Review of Geologic and Hydrologic Issues Related to Waste Isolation in Columbia River Basalts with questions for HJMiller from JBM

REVIEW OF GEOLOGIC AND HYDROLOGIC ISSUES
RELATED TO WASTE ISOLATION IN
COLUMBIA RIVER BASALTS

TECHNICAL REPORT

Office of National Waste Terminal Storage Integration
Battelle Memorial Institute
Columbus, Ohio 43201

FIGURE 3. LOCATIONS OF DEEP BORE HOLES

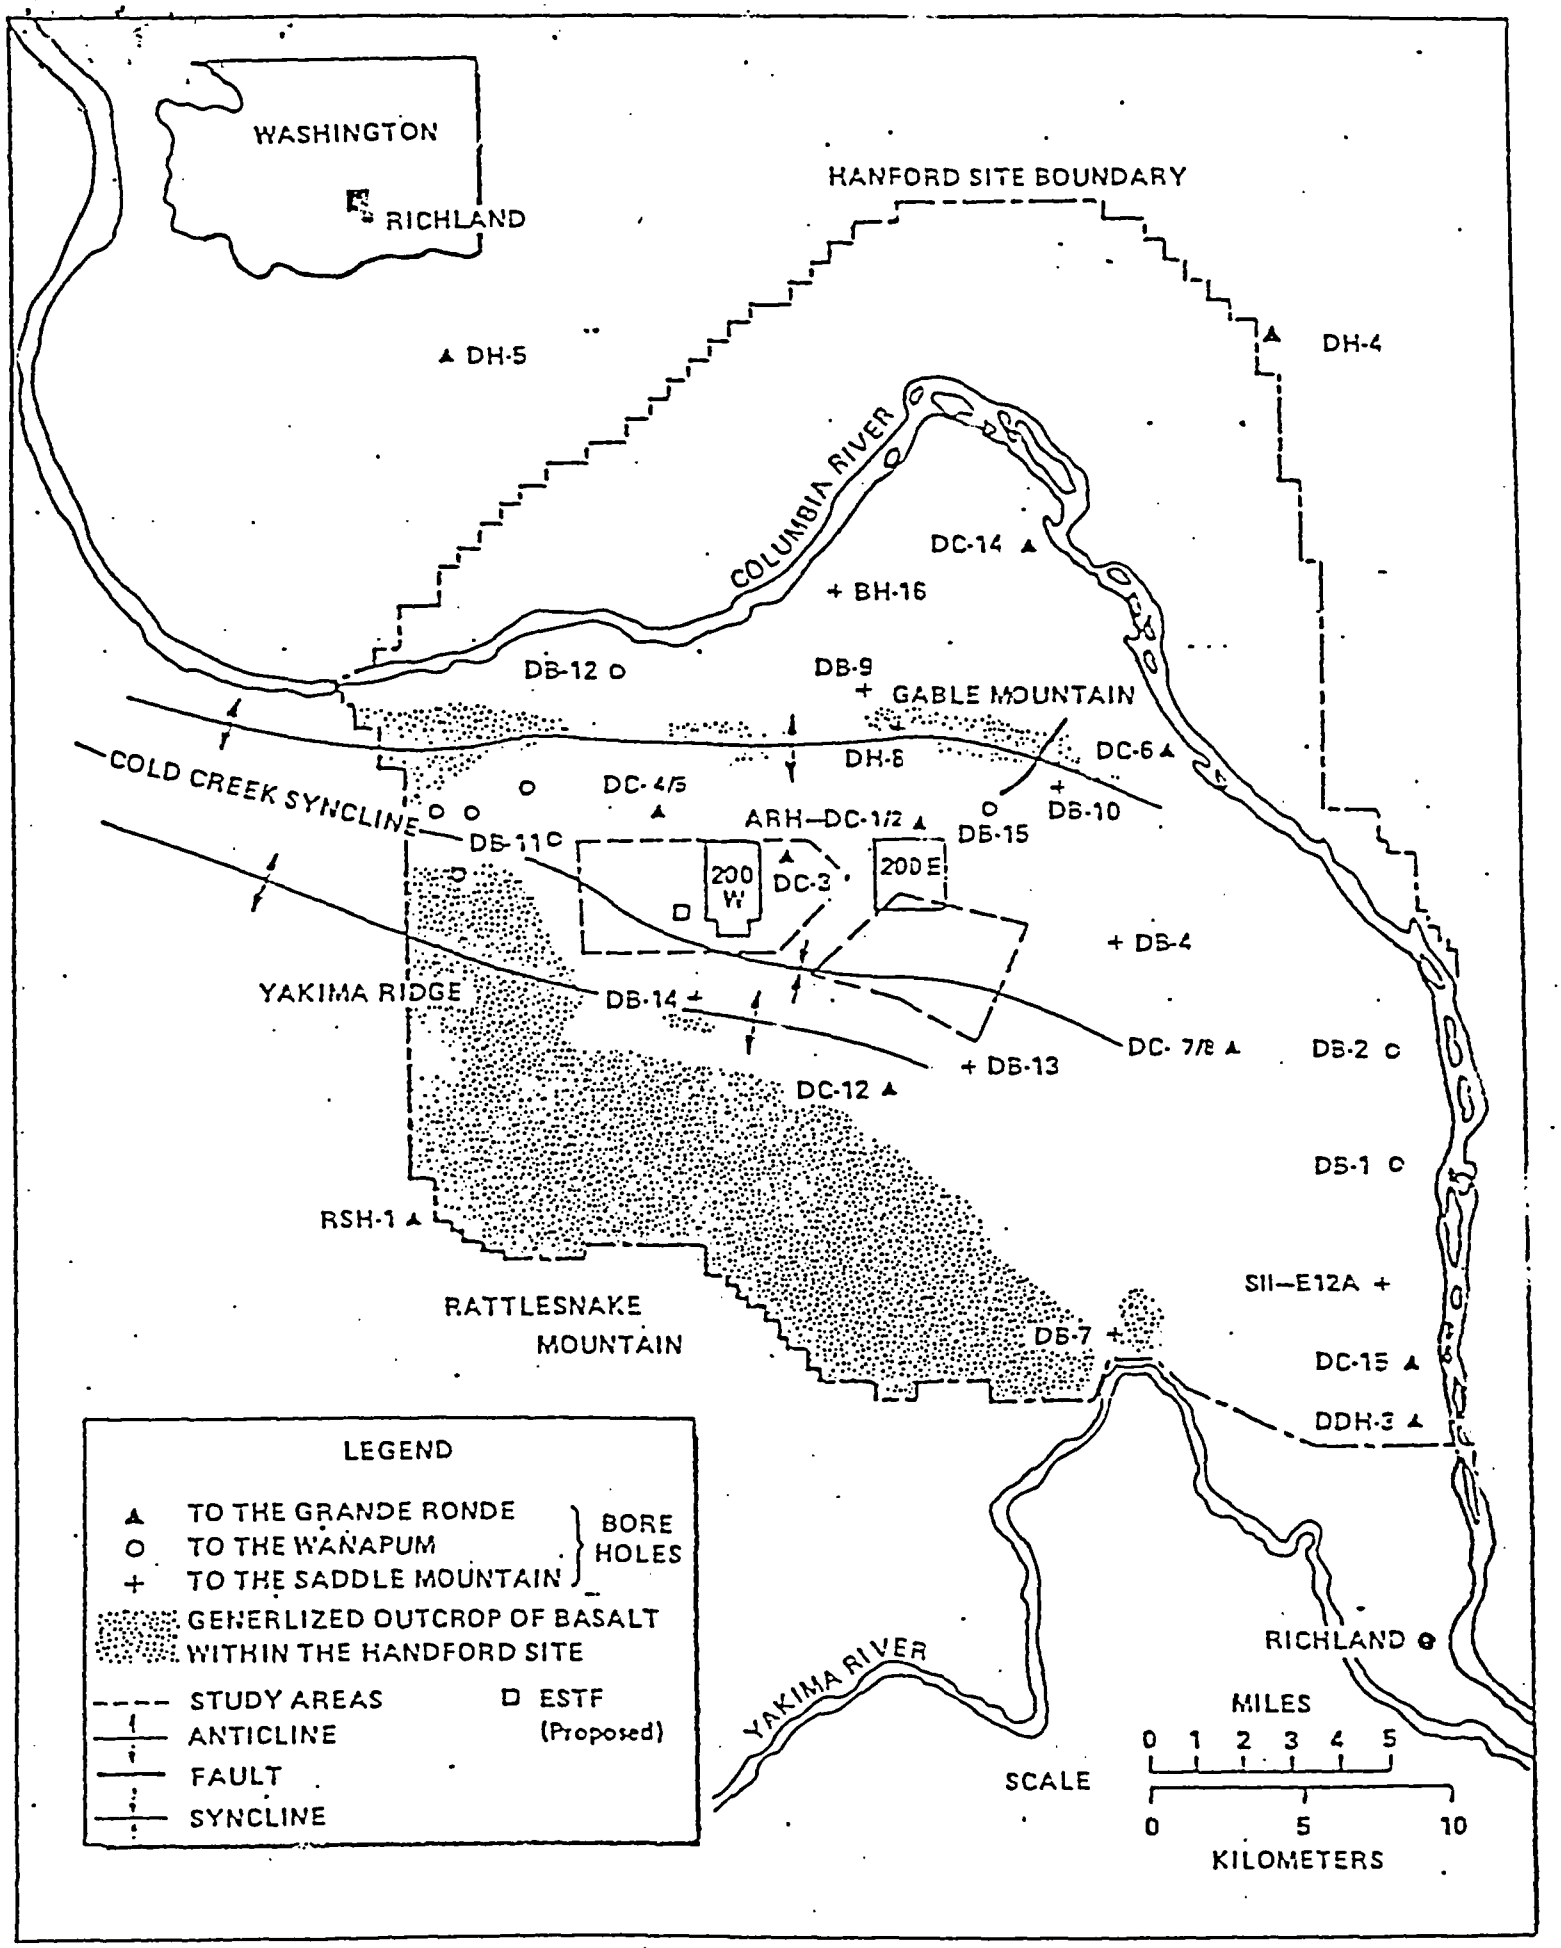
Current plans for the exploratory shaft test facility (ESTF, Figure 3) are to drill a rotary hole to obtain stratigraphy and use this information to design the shaft. A second hole, a core hole, would then be drilled for hydrologic testing. Both holes would be outside of the shaft area.

FIGURE 4. CONCEPTUAL MODEL OF THE REGIONAL GROUND-WATER FLOW IN THE COLUMBIA RIVER BASALTS

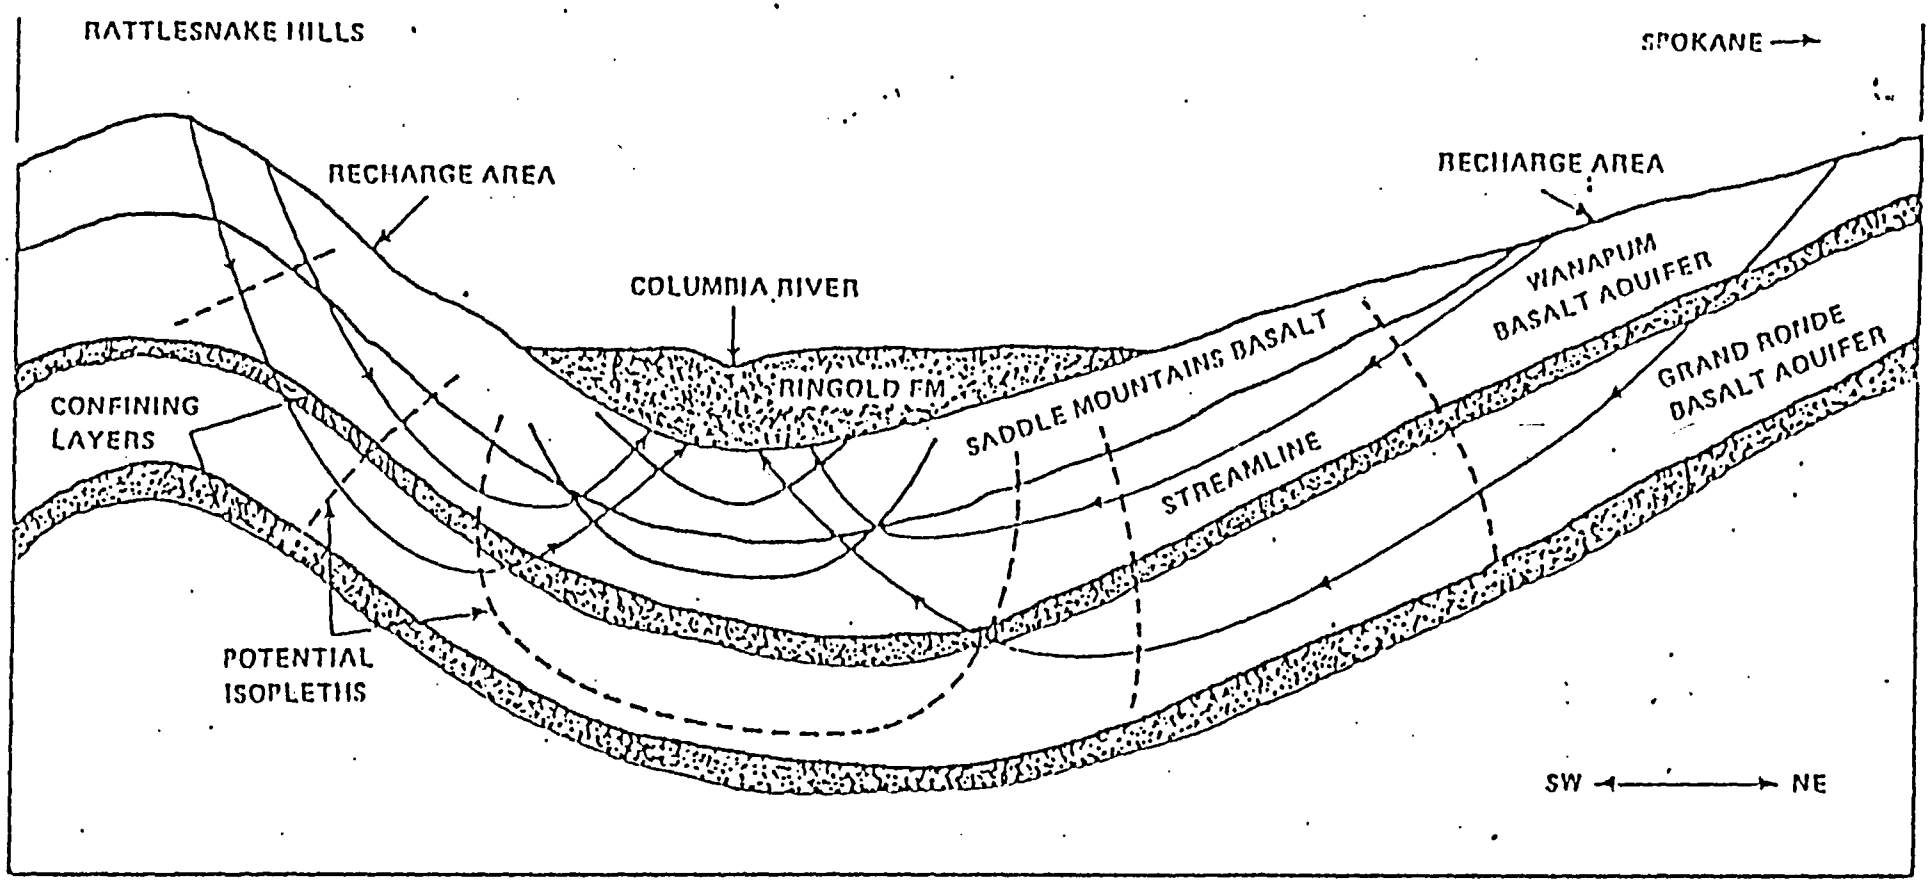
Geochemical stratification of the waters in the basalt sequence has been presented as support for the argument that the flow in the Grande Ronde is separated from that of the overlying Saddle Mountains and Wanapum basalts. However, this argument can only be supported by showing that the simple conceptual flow model of the basalt sequence (Figure 4) is not compatible with the geochemical stratification.

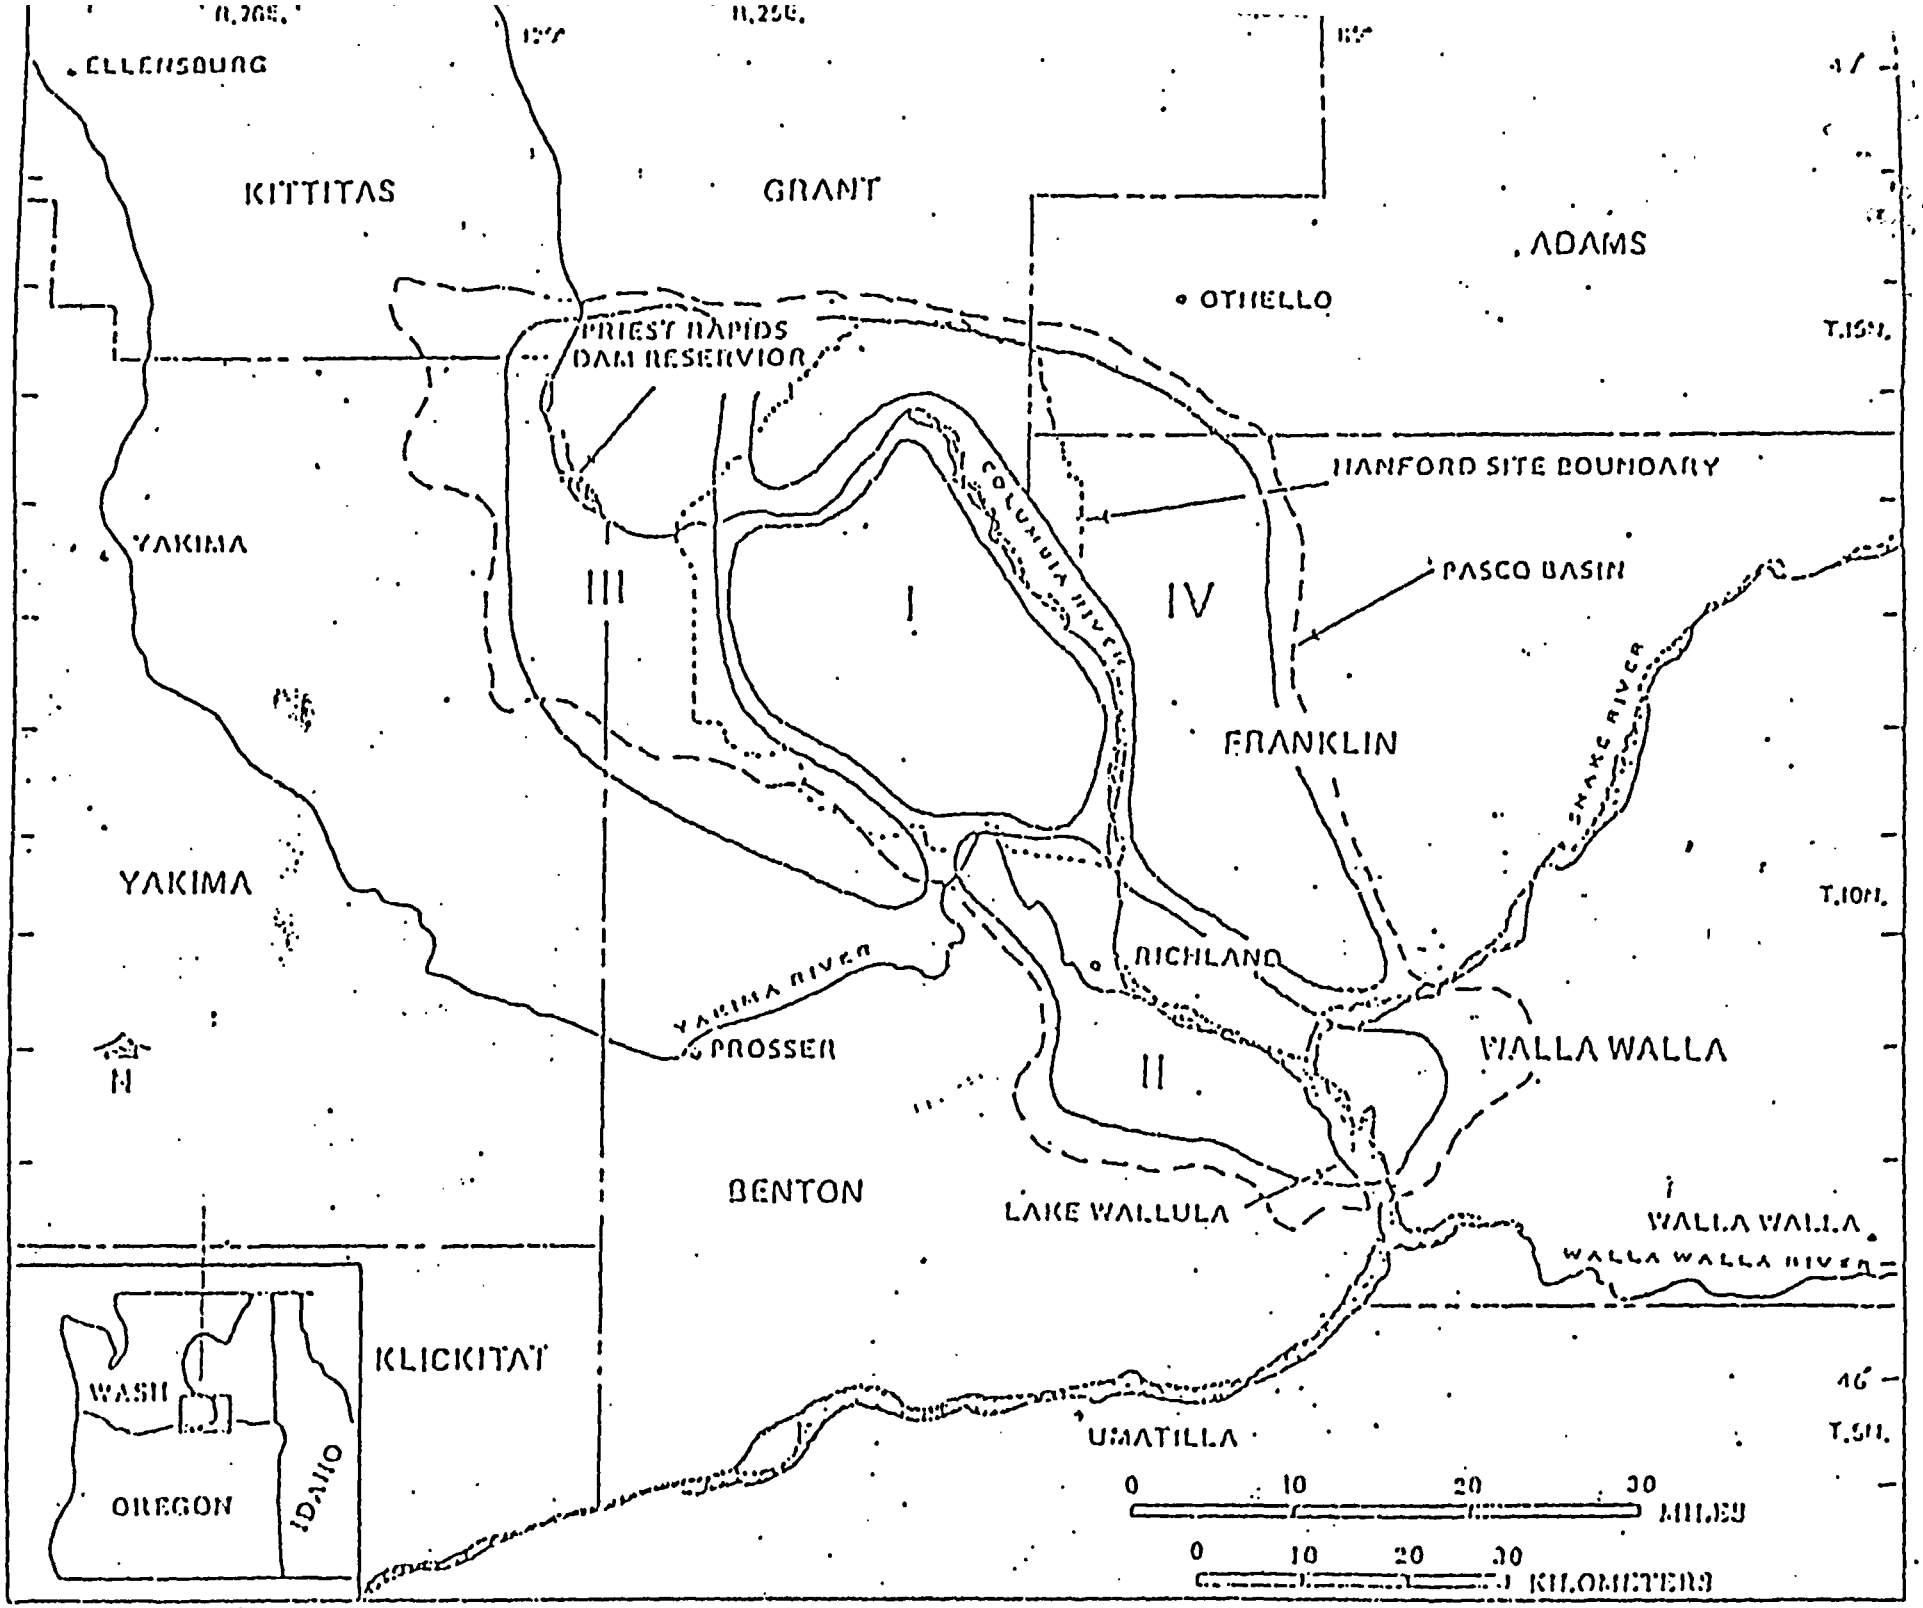
A2.1. The HIR makes the case that the most likely discharge area for the Columbia River basalts is the Lake Wallula portion of the Columbia River (Region II, enclosed Figure 1). The reason for the espousal of the Lake Wallula discharge area appears to be the apparent lack of hydraulic interconnection between the interbed aquifers beneath the Columbia River in the vicinity of the Hanford Site (HIR II-147; III-199(b);

Fig. 3

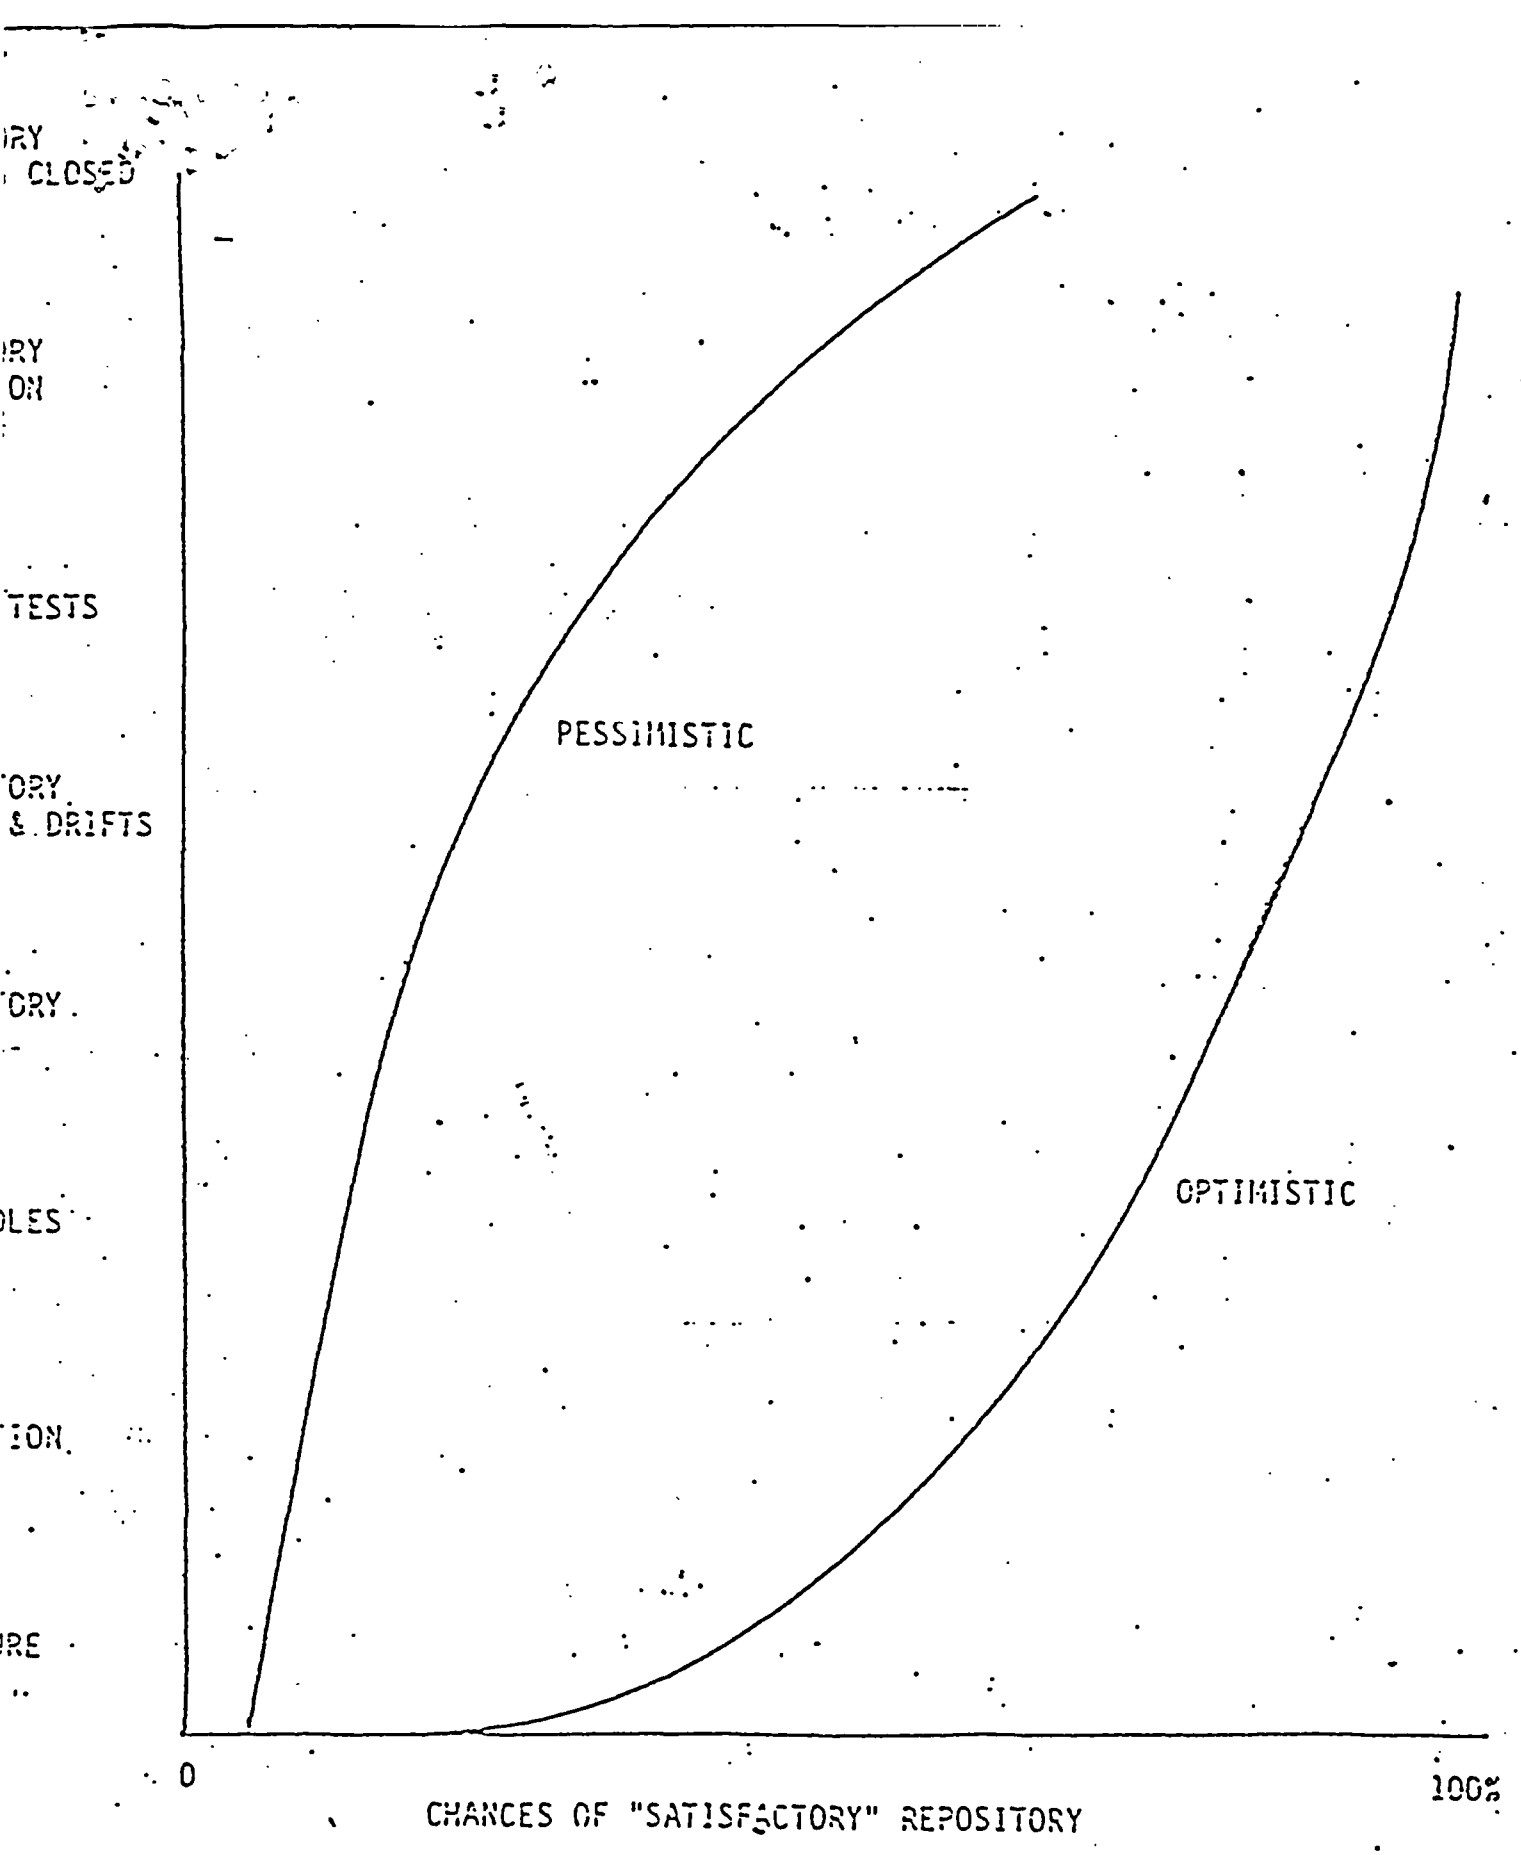
After reviewing what has been discussed in the above pages, a logical conclusion might be "reasonably good program, potentially poor site". Although the Overview Committee is in general accord with this statement, it should be recognized that technical experts of good and equal competence and of good will might, without prejudice, arrive at very different conclusions based upon their experience and upon how risk-adverse they may or may not be. For example, as shown in Figure 3, a risk-adverse person might follow a curve that would be essentially only the abscissa.* That is, he would not have any confidence in the success of a repository until the repository had been in place for 10,000 years or more. At the opposite pole would be a person who, from a cursory glance at the literature, would have 100% belief in the success of a repository. His curve would lie along the ordinate.

At this stage of the investigation of the Columbia River basalts, the program is still within the drill hole phase of Figure 3 and, from the point of view of hydrological attributes, the envelope of confidence lies within the pessimistic region. There is one solid reason for this, namely, that "proving" the Hanford site is equivalent to "proving" the integrity of the individual basalt flow in which the repository is to be emplaced, in this case, most likely the Umtanum. That is to say, the main line of defense against radionuclide transport (other than the engineered repository) would appear to lie in the basalt flows themselves. We do not believe that such "proving" can be accomplished by drilling alone. It is unlikely that the scientific community, or the public, will be persuaded as to site suitability without a deep test facility; i.e., embarking on the exploratory shafts, tunnels, drifts, and in situ testing of the type shown on Figure 3 and espoused by Dr. P. A. Witherspoon in his letter of November 23, 1979, to Colin Heath.
